## REMARKS

This is an Amendment and Reply to the Office Action dated February 13, 2004. Claims 1-9 are pending in this application. By this Amendment, claims 1-9 have been cancelled and claims 10-23 have been added. Accordingly, claims 10-23 are now at issue.

Fig. 2

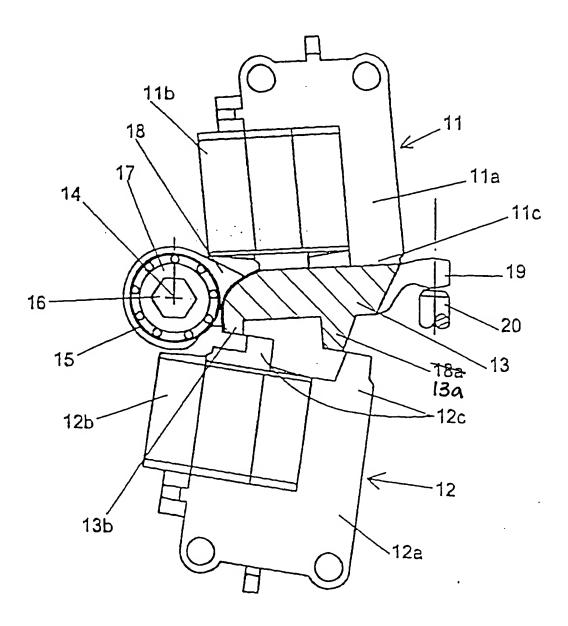
The Examiner has objected to FIG. 2 of the drawings for failing to identify element number 13a and also including element number 18a, which is not discussed in the specification. The Applicant submits that the element that element number "18a" refers to was inadvertently mislabeled. This element should have been labeled as "13a." Accordingly, the drawings have been amended to correct this error. The Applicants respectfully request approval of the amended drawings.
